TOWN OF BAY HARBOR ISLANDS MORRIS N. BROAD COMMUNITY CENTER

**DEVELOPMENT & REVIEW COMMITTEE MEETING
THURSDAY, MAY 9, 2024**

Subject: Site Development Plan Application - #1 Review & Comments
10150-10190 East Bay Harbor Drive & 1075 101 St. – 20 DU Townhouses
Bay Harbor Islands Acct. No. SPR2024-000011
MMPA Acct. No. 01-0702-1190

A3.01
PLANNING
& ZONING
2021.05.10

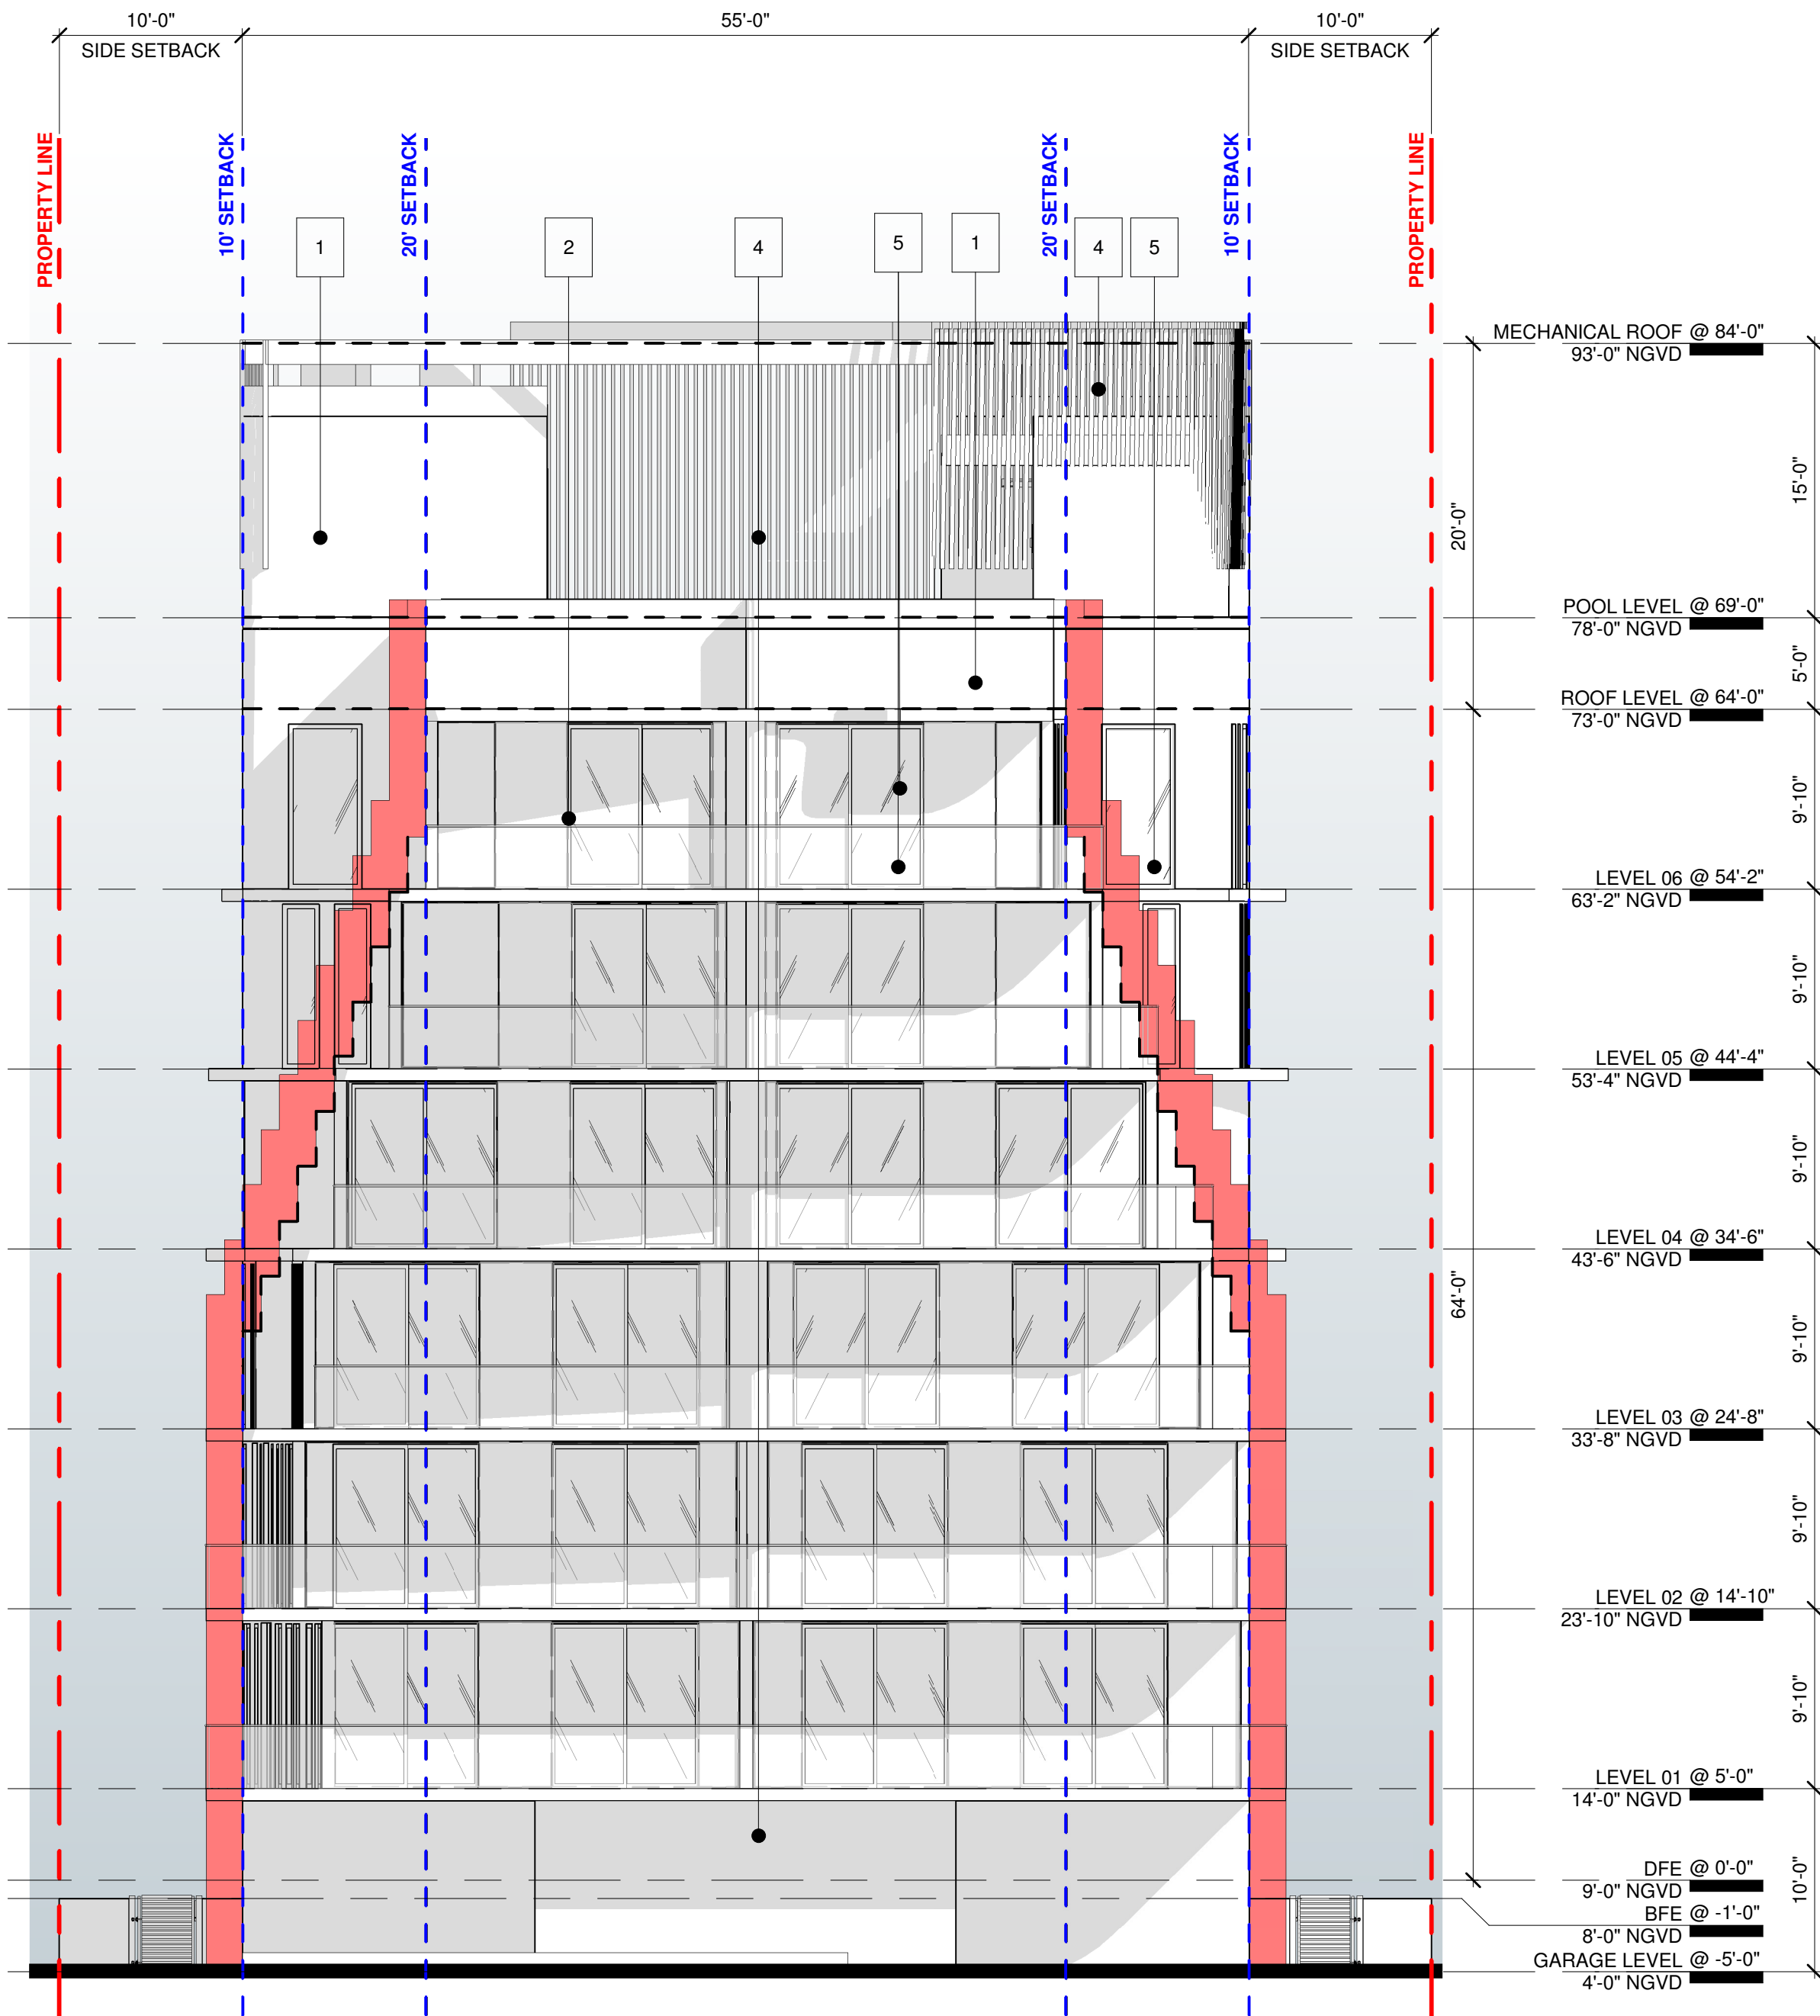
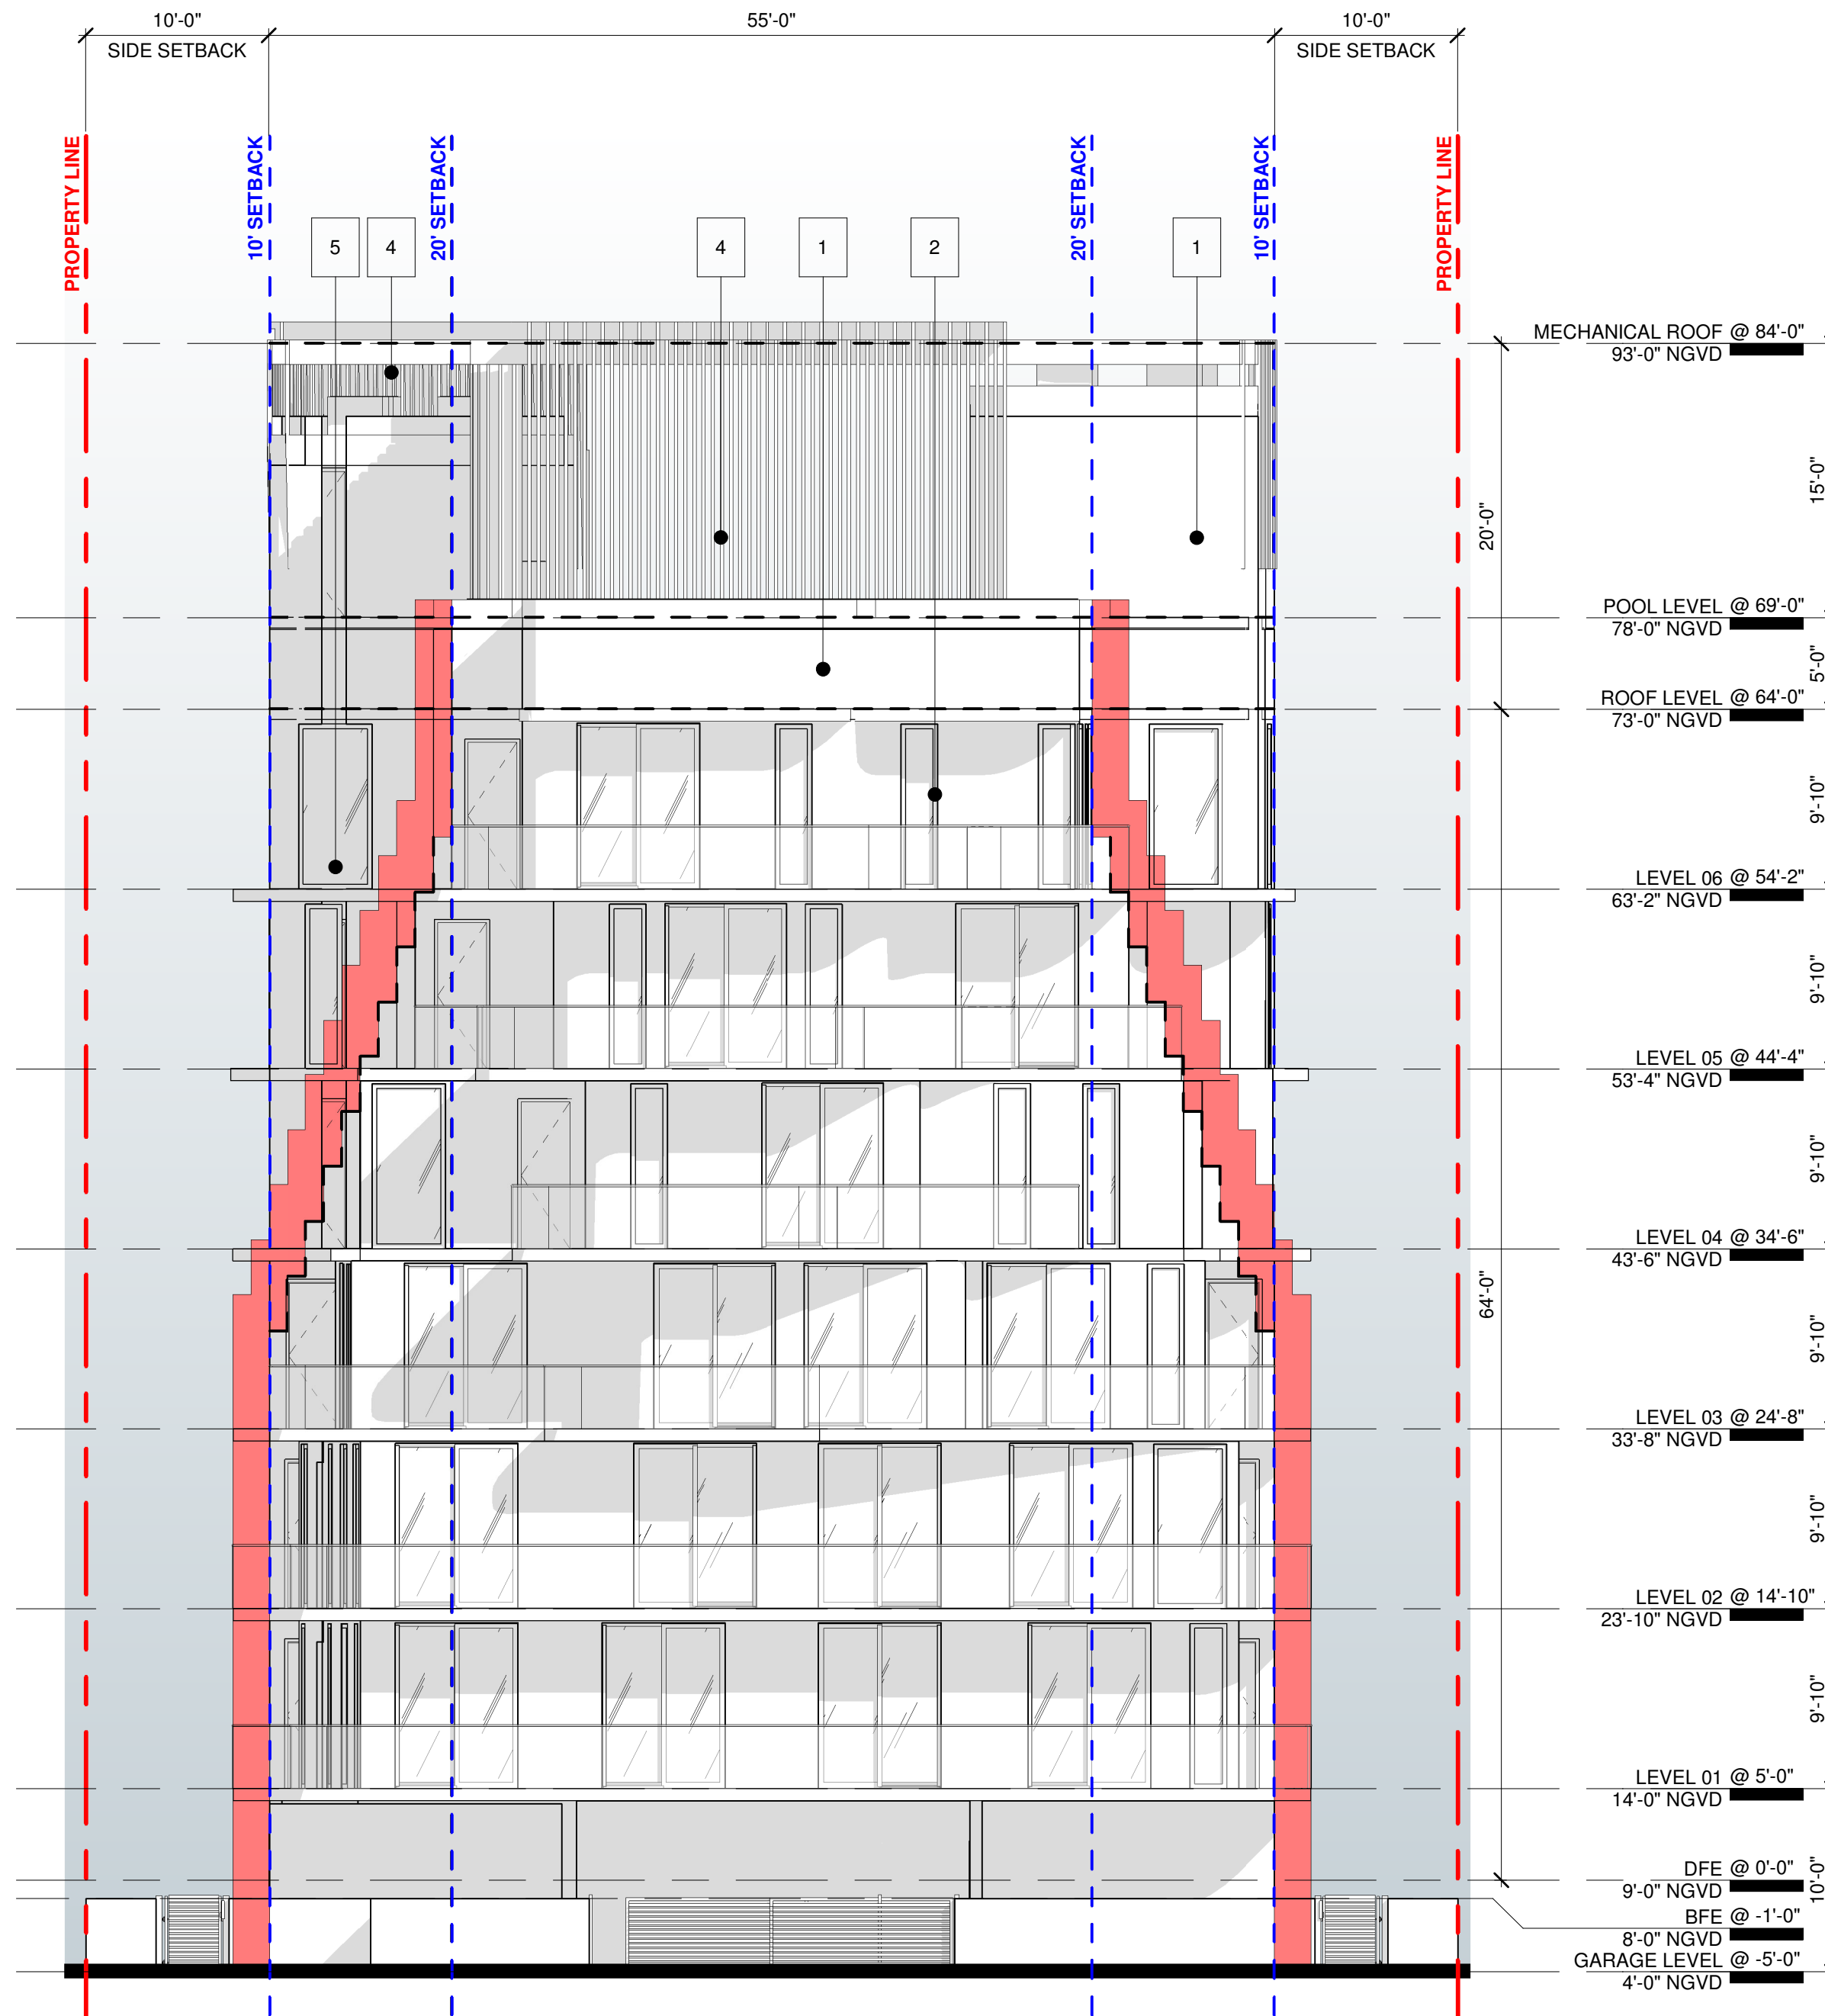
24. On Sheets A3.01 / A3.02 / A3.03 / A4.01 / A4.02 / A4.03 the cross sections appear to show several rooftop structures that may be too large / too tall / not allowed. The Town's urban design goal / idea is to minimize building height – especially rooftop structures – and to push them into the center of the roof area (except for elevator / stairs to meet fire / safety codes). Shade structures are allowed but not to exceed 10' above the main roof deck and setback at least 15' from the edge of the main roof line. Cantilevered / spanned structures can be allowed between the above but not as a main architectural feature.
